REMARKS

Amendments to the Drawings:

FIG. 1

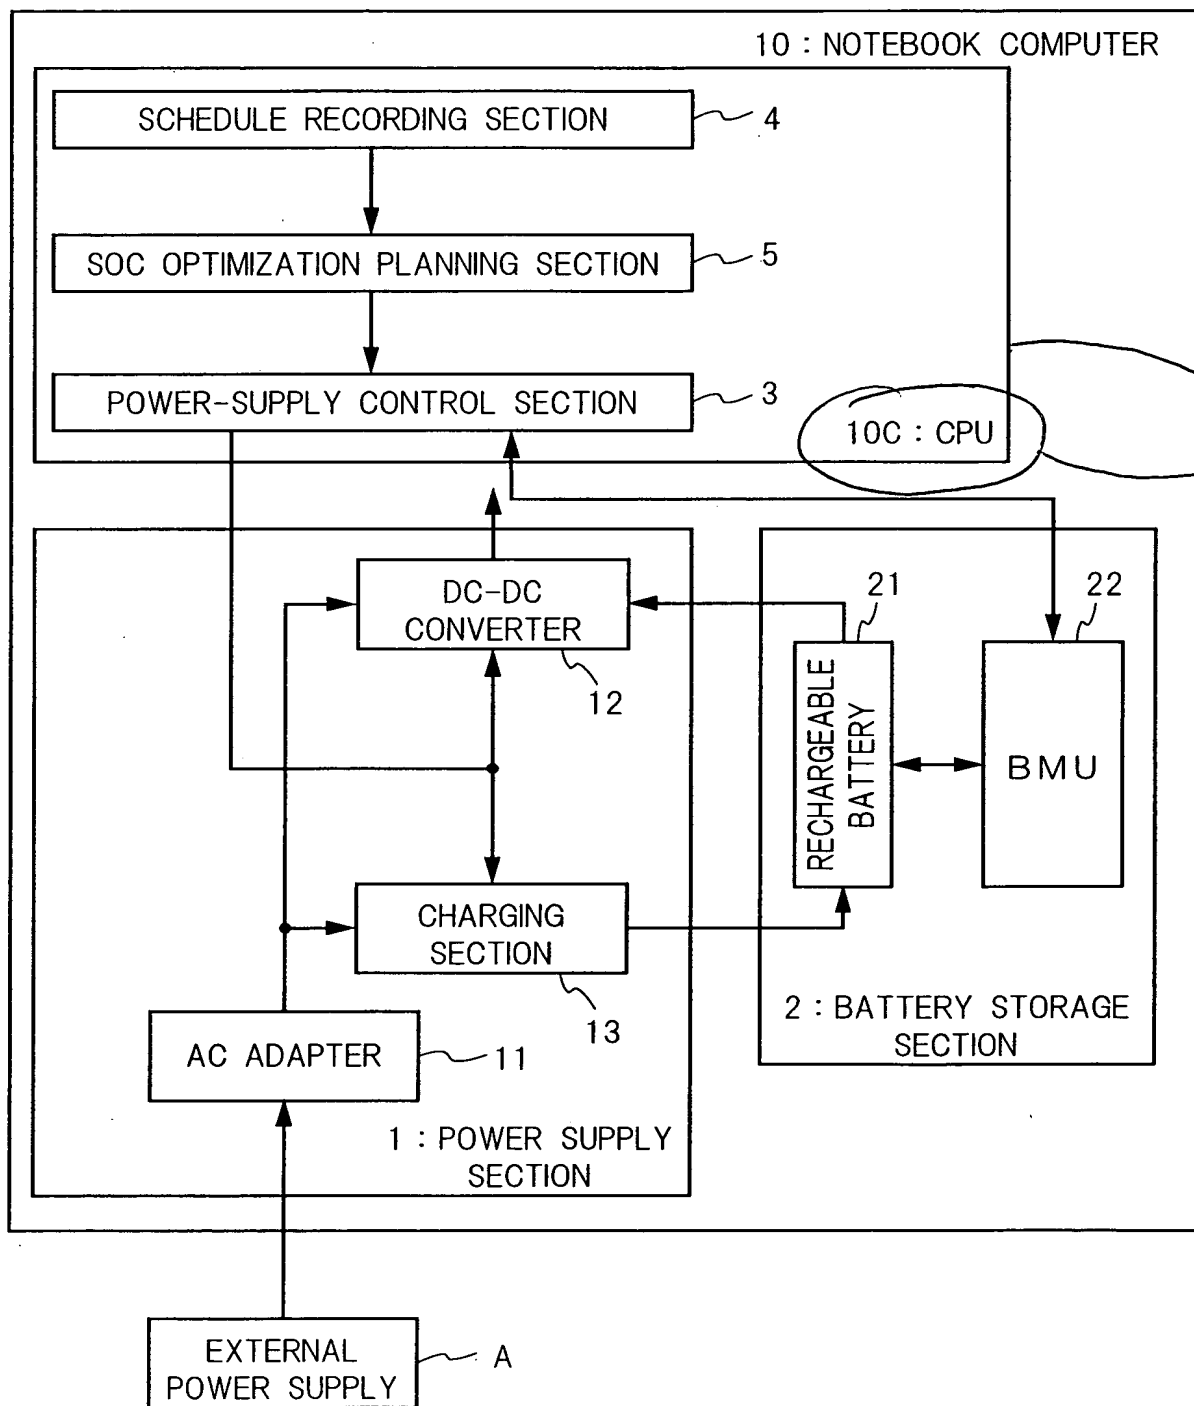
The Examiner objected to the figures because the figures do not show every feature of the invention specified in the claims. Applicant has attached an Appendix to this Amendment, including replacement sheets and an annotated sheets for Figs. 1 and 4 showing changes for the Examiner's approval. The CPU 10C and 30C is shown in both Figs.1 and 4, the battery storage section 2 is shown in Fig 1, the power supply section 1 is shown in Fig. 1, the charge state optimization planning section 5A is shown in Fig 4. Having made the requested corrections, Applicant respectfully requests reconsideration and withdrawal of the objections to the drawings.

The attached sheets of drawings include changes to Figs. 1 and 4. These sheets, which include Figs. 1 and 4 replace the original sheets including Figs. 1 and 4. In Figs. 1 and 4, the elements included in the CPU have been enclosed in a box labeled CPU.
